CITY OF TAKOMA PARK
HOUSING AND COMMUNITY DEVELOPMENT
ETHAN ALLEN GATEWAY STREETScape

ADDENDUM NO. 1,
MARCH 15, 2017
SHEET No's: 5, 24, 25
& 26

**ETHAN ALLEN GATEWAY
STREETSCAPE**

Δ ADDENDUM REVISION NO. 1 - MARCH 15, 2017

GRINDING AND RESURFACING
PAVEMENT DETAIL H

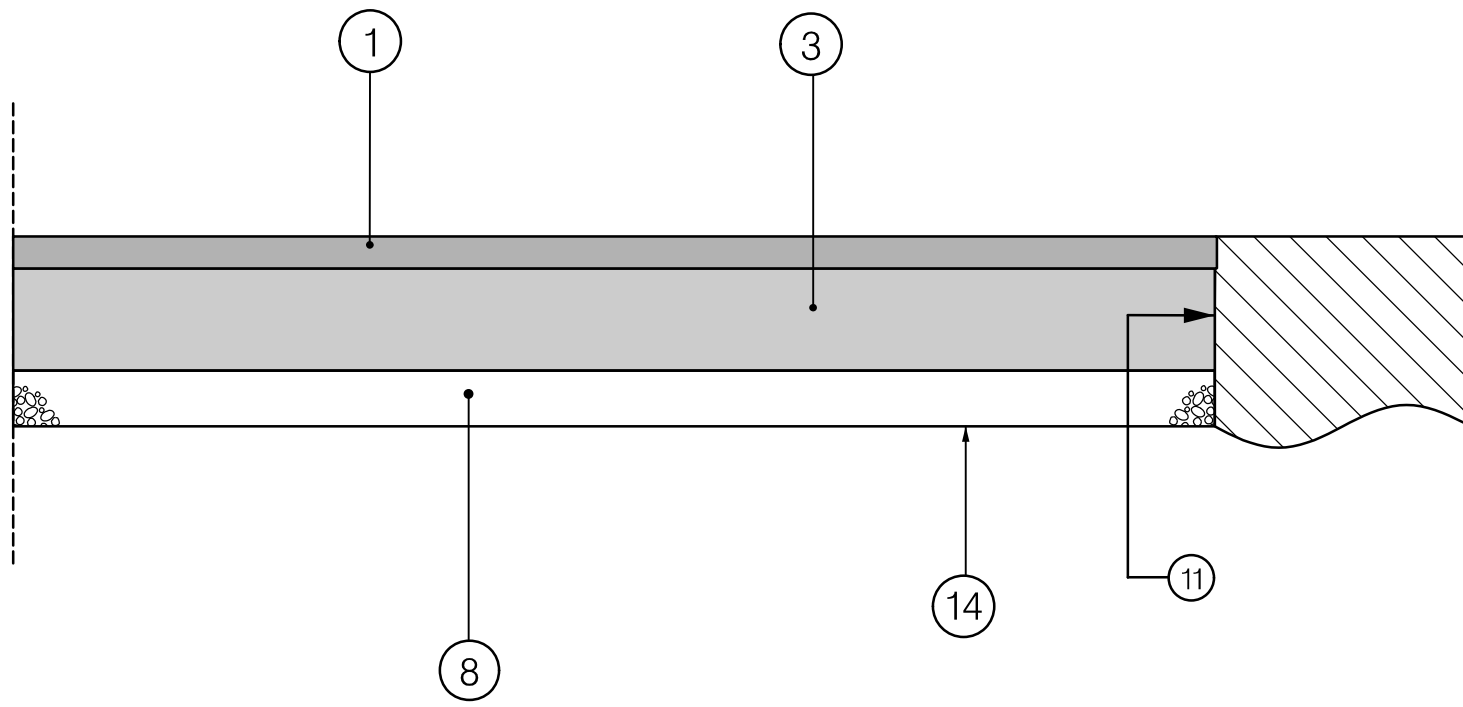
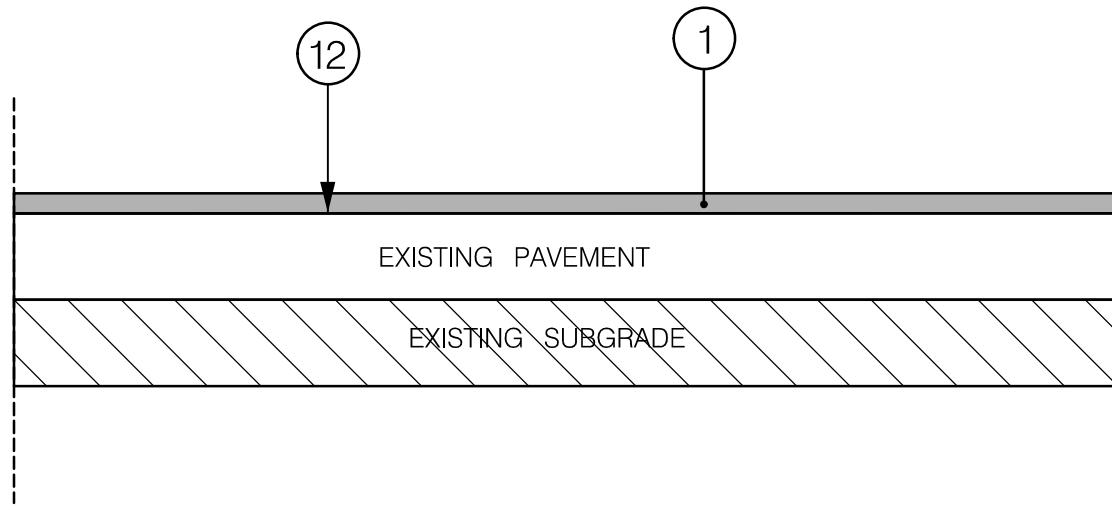
△ GRINDING ASPHALT PAVEMENT 0 INCH TO 2 INCH		
STA. 302+58 TO STA. 307+96, RT	2,655 SY	
STA. 304+08 TO STA. 304+20, RT	8 SY	
STA. 302+58 TO STA. 307+96, LT	2,386 SY	
STA. 303+50 TO STA. 304+39, LT	57 SY	
STA. 305+38 TO STA. 305+67, LT	31 SY	
△ 9 INCH PLAIN PORTLAND CEMENT CONCRETE, MIX 9		
STA. 307+17.91 TO STA. 307+94.97, RT	88 SY	
STA. 303+81.03 TO STA. 304+67.50, LT	94 SY	
△ 8 INCH PORTLAND CEMENT CONCRETE FOR DRIVEWAY, MIX 9		
STA. 303+41.46 TO STA. 303+46.24, RT	4 SY	
STA. 303+51.65 TO STA. 303+86.55, RT	25 SY	
STA. 306+79.37 TO STA. 307+19.54, RT	66 SY	
STA. 303+36.52 TO STA. 303+85.67, LT	70 SY	
STA. 305+52.39 TO STA. 305+64.13, LT	7 SY	
△ STANDARD TYPE A COMBINATION CURB AND GUTTER, ANY HEIGHT OR DEPTH		
STA. 303+41.46 TO STA. 303+86.55, RT	44 LF	
STA. 303+96.72 TO STA. 304+30.76, RT	85 LF	
STA. 304+32.98 TO STA. 304+58.26, RT	67 LF	
STA. 304+91.32 TO STA. 307+94.70, RT	373 LF	
STA. 306+35.19 TO STA. 307+95.53, RT (MEDIAN)	325 LF

ROADWAY PLAN

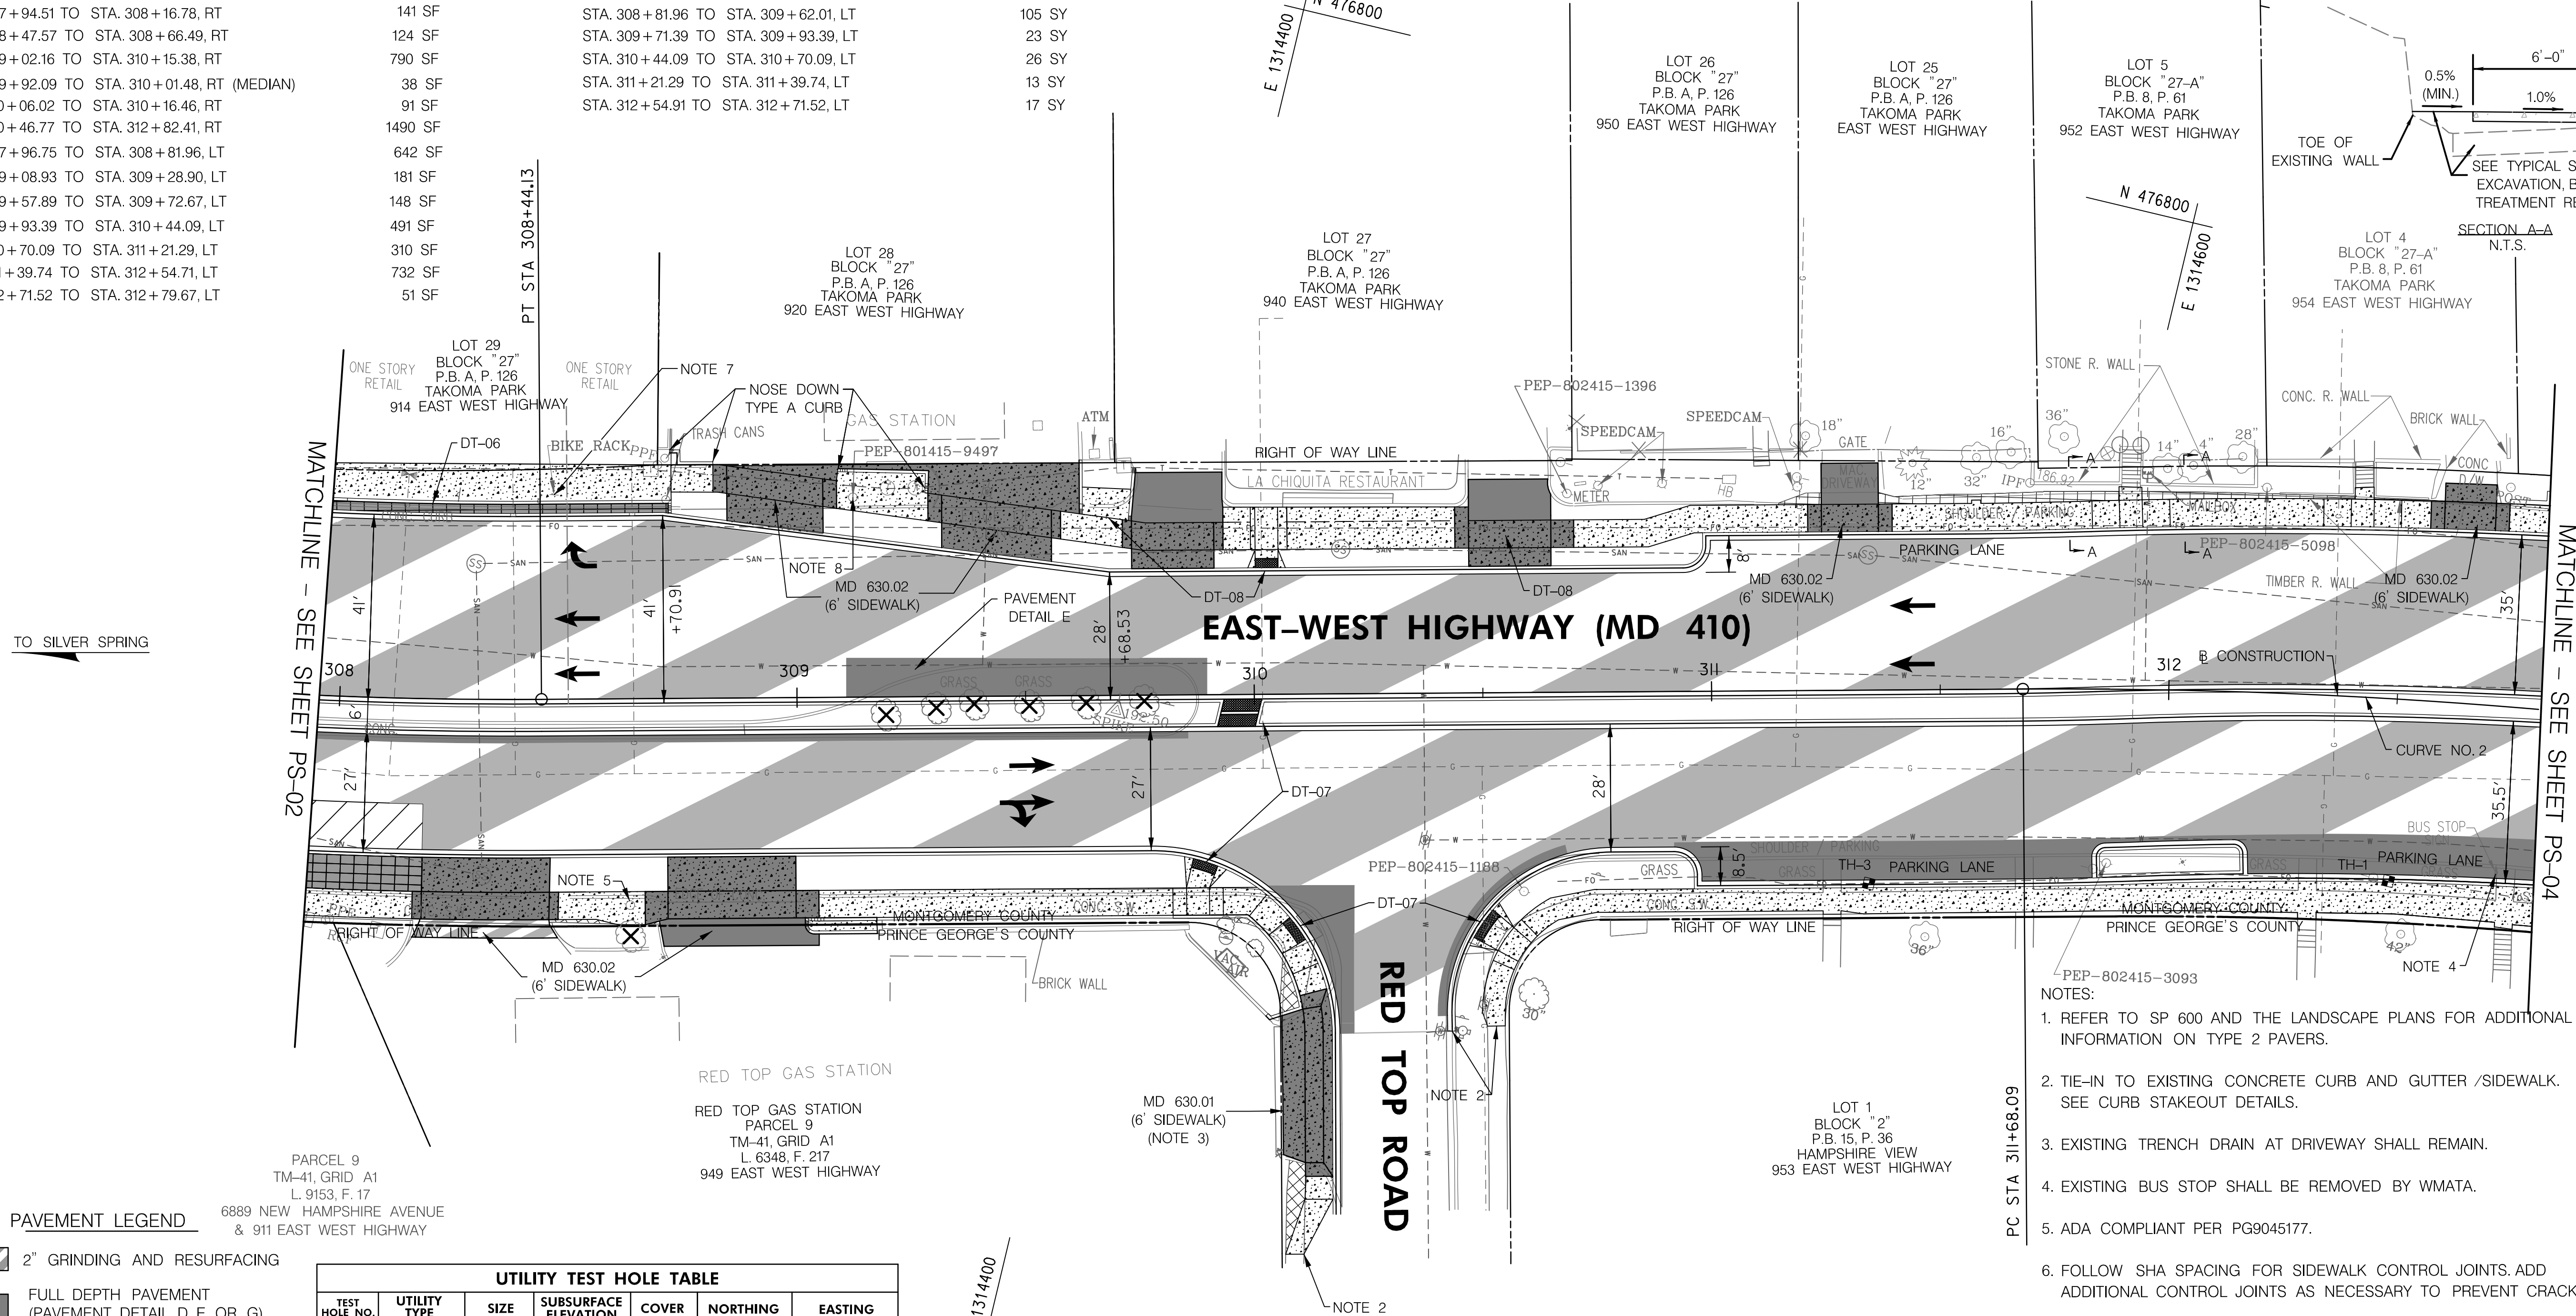
△ STANDARD TYPE A CURB ANY HEIGHT OR DEPTH

STA. 309+01.49 TO STA. 309+17.13, RT	34 LF
STA. 309+81.91 TO STA. 310+10.16, RT	49 LF
STA. 311+84.51 TO STA. 312+17.59, RT	32 LF
STA. 309+91.92 TO STA. 309+93.41, RT (MEDIAN)	6 LF
STA. 310+00.16 TO STA. 310+01.65, RT (MEDIAN)	6 LF
STA. 307+96.73 TO STA. 308+72.12, LT	75 LF
STA. 308+72.50 TO STA. 308+81.94, LT	13 LF
STA. 309+09.33 TO STA. 309+28.92, LT	25 LF
STA. 309+62.01 TO STA. 309+62.04, LT	12 LF
STA. 309+73.39 TO STA. 309+74.39, LT	11 LF
STA. 312+71.31 TO STA. 312+79.97, LT	9 LF

△ 5 INCH CONCRETE SIDEWALK

STA. 307+94.51 TO STA. 308+16.78, RT	141 SF
STA. 308+47.57 TO STA. 308+66.49, RT	124 SF
STA. 309+02.16 TO STA. 310+15.38, RT	790 SF
STA. 309+92.09 TO STA. 310+01.48, RT (MEDIAN)	38 SF
STA. 310+06.02 TO STA. 310+16.46, RT	91 SF
STA. 310+46.77 TO STA. 312+82.41, RT	1490 SF
STA. 307+96.75 TO STA. 308+81.96, LT	642 SF
STA. 309+08.93 TO STA. 309+28.90, LT	181 SF
STA. 309+57.89 TO STA. 309+72.67, LT	148 SF
STA. 309+93.39 TO STA. 310+44.09, LT	491 SF
STA. 310+70.09 TO STA. 311+21.29, LT	310 SF
STA. 311+39.74 TO STA. 312+54.71, LT	732 SF
STA. 312+71.52 TO STA. 312+79.67, LT	51 SF

△ GRINDING ASPHALT PAVEMENT 0 INCH TO 2 INCH

STA. 307+96 TO STA. 312+81, RT	1,511 SY
STA. 308+16 TO STA. 308+47, RT	13 SY
STA. 307+96 TO STA. 312+81, LT	1,435 SY

△ 9 INCH PLAIN PORTLAND CEMENT CONCRETE, MIX 9

STA. 307+94.97 TO STA. 308+18.70, LT	28 SY
--------------------------------------	-------

△ 8 INCH PORTLAND CEMENT CONCRETE FOR DRIVEWAY, MIX 9

STA. 308+16.78 TO STA. 308+47.57, RT	45 SY
STA. 308+66.50 TO STA. 309+04.50, RT	49 SY
STA. 310+05.61 TO STA. 310+16.56, RT	44 SY
STA. 308+81.96 TO STA. 309+62.01, LT	105 SY
STA. 309+71.39 TO STA. 309+93.39, LT	23 SY
STA. 310+44.09 TO STA. 310+70.09, LT	26 SY
STA. 311+21.29 TO STA. 311+39.74, LT	13 SY
STA. 312+54.91 TO STA. 312+71.52, LT	17 SY

△ STANDARD TYPE A COMBINATION CURB AND GUTTER, ANY HEIGHT OR DEPTH

STA. 307+94.70 TO STA. 310+17.23, RT	287 LF
STA. 310+42.76 TO STA. 312+82.38, RT	305 LF
STA. 307+95.37 TO STA. 312+81.08, RT (MEDIAN)	486 LF
STA. 307+95.52 TO STA. 311+99.38, RT (MEDIAN)	404 LF
STA. 311+99.38 TO STA. 312+80.88, LT (MEDIAN)	82 LF
STA. 307+96.64 TO STA. 312+79.68, LT	490 LF

△ DETECTABLE WARNING SURFACE FOR CURB RAMPS (RED) MD-655.40

STA. 310+89, RT	11 SF
STA. 309+96, RT (MEDIAN)	16 SF
STA. 309+97, RT (MEDIAN)	16 SF
STA. 310+09, RT	12 SF
STA. 310+50, RT	14 SF
STA. 310+03, LT	10 SF

△ SPECIALTY PAVER - TYPE 2

STA. 307+94.69 TO STA. 308+18.70, RT	188 SF
STA. 307+96.66 TO STA. 308+72.12, LT	147 SF

SCALE: 1" = 20' SHEET 26 OF 85

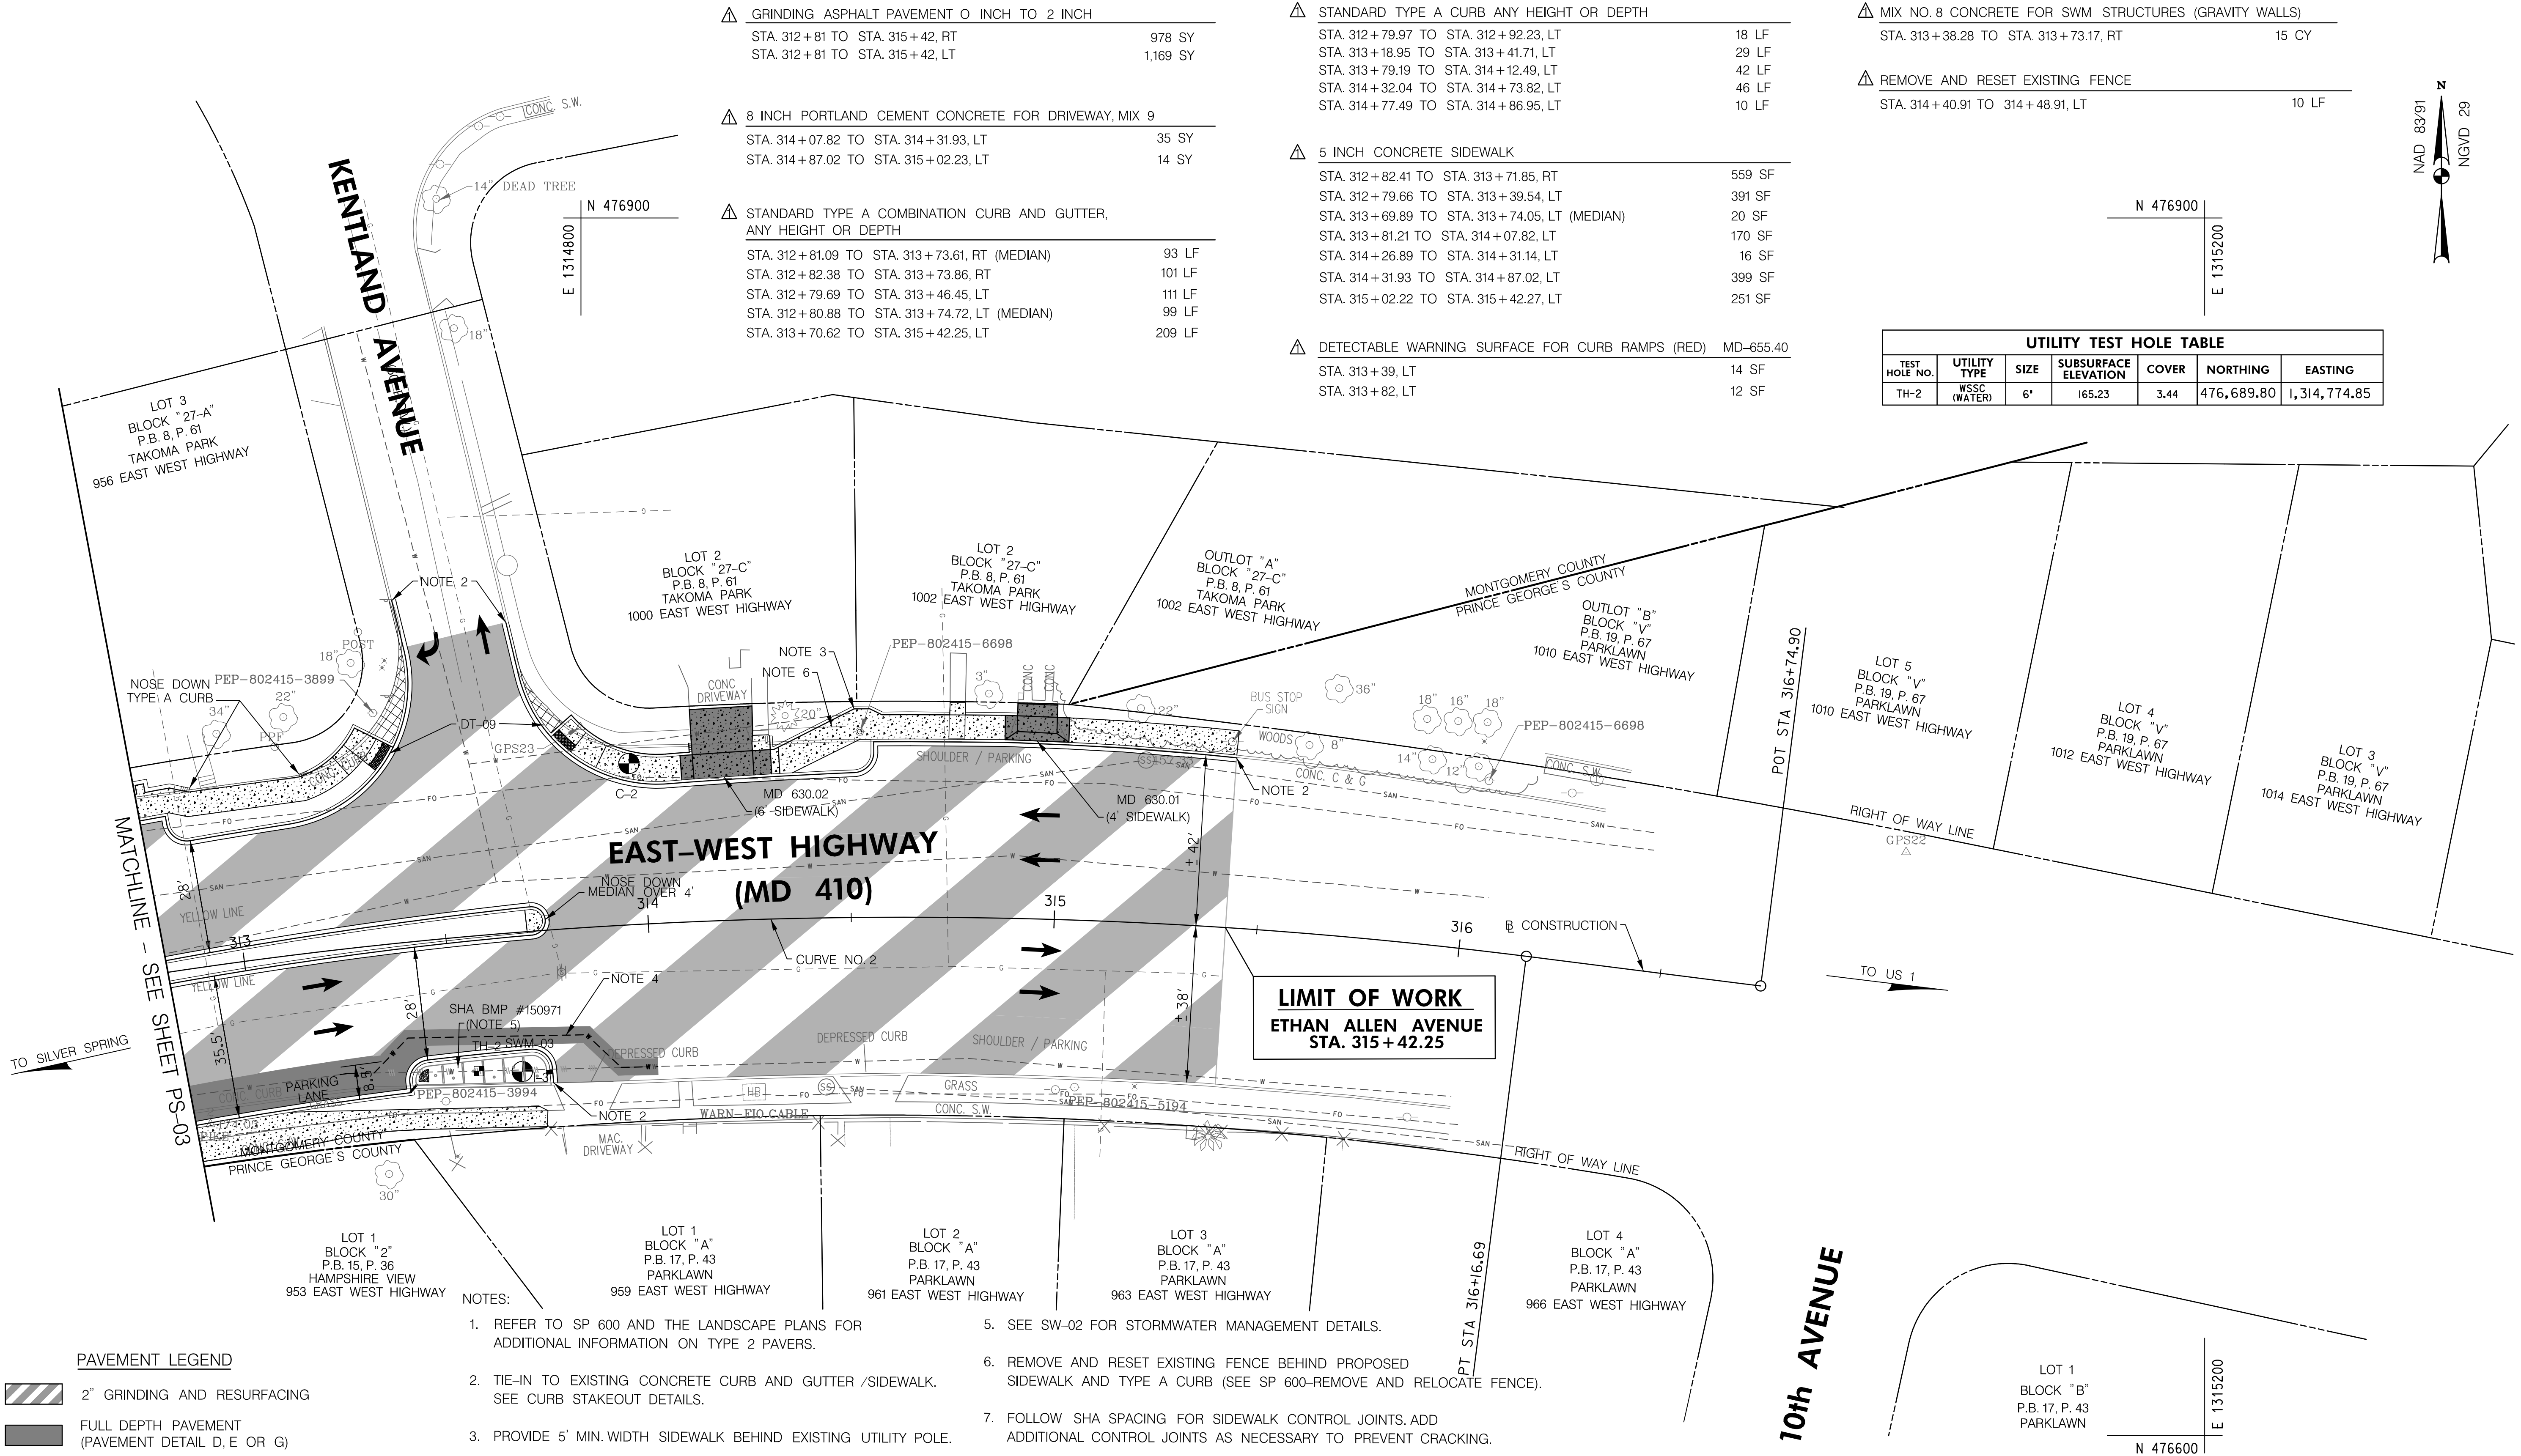
GRINDING ASPHALT PAVEMENT 0 INCH TO 2 INCH	
STA. 312+81 TO STA. 315+42, RT	978 SY
STA. 312+81 TO STA. 315+42, LT	1,169 SY
8 INCH PORTLAND CEMENT CONCRETE FOR DRIVEWAY, MIX 9	
STA. 314+07.82 TO STA. 314+31.93, LT	35 SY
STA. 314+87.02 TO STA. 315+02.23, LT	14 SY
STANDARD TYPE A COMBINATION CURB AND GUTTER, ANY HEIGHT OR DEPTH	
STA. 312+81.09 TO STA. 313+73.61, RT (MEDIAN)	93 LF
STA. 312+82.38 TO STA. 313+73.86, RT	101 LF
STA. 312+79.69 TO STA. 313+46.45, LT	111 LF
STA. 312+80.88 TO STA. 313+74.72, LT (MEDIAN)	99 LF
STA. 313+70.62 TO STA. 315+42.25, LT	209 LF

STANDARD TYPE A CURB ANY HEIGHT OR DEPTH	
STA. 312+79.97 TO STA. 312+92.23, LT	18 LF
STA. 313+18.95 TO STA. 313+41.71, LT	29 LF
STA. 313+79.19 TO STA. 314+12.49, LT	42 LF
STA. 314+32.04 TO STA. 314+73.82, LT	46 LF
STA. 314+77.49 TO STA. 314+86.95, LT	10 LF
5 INCH CONCRETE SIDEWALK	
STA. 312+82.41 TO STA. 313+71.85, RT	559 SF
STA. 312+79.66 TO STA. 313+39.54, LT	391 SF
STA. 313+69.89 TO STA. 313+74.05, LT (MEDIAN)	20 SF
STA. 313+81.21 TO STA. 314+07.82, LT	170 SF
STA. 314+26.89 TO STA. 314+31.14, LT	16 SF
STA. 314+31.93 TO STA. 314+87.02, LT	399 SF
STA. 315+02.22 TO STA. 315+42.27, LT	251 SF
DETECTABLE WARNING SURFACE FOR CURB RAMPS (RED) MD-655.40	
STA. 313+39, LT	14 SF
STA. 313+82, LT	12 SF

MIX NO. 8 CONCRETE FOR SWM STRUCTURES (GRAVITY WALLS)	
STA. 313+38.28 TO STA. 313+73.17, RT	15 CY
REMOVE AND RESET EXISTING FENCE	
STA. 314+40.91 TO STA. 314+48.91, LT	10 LF
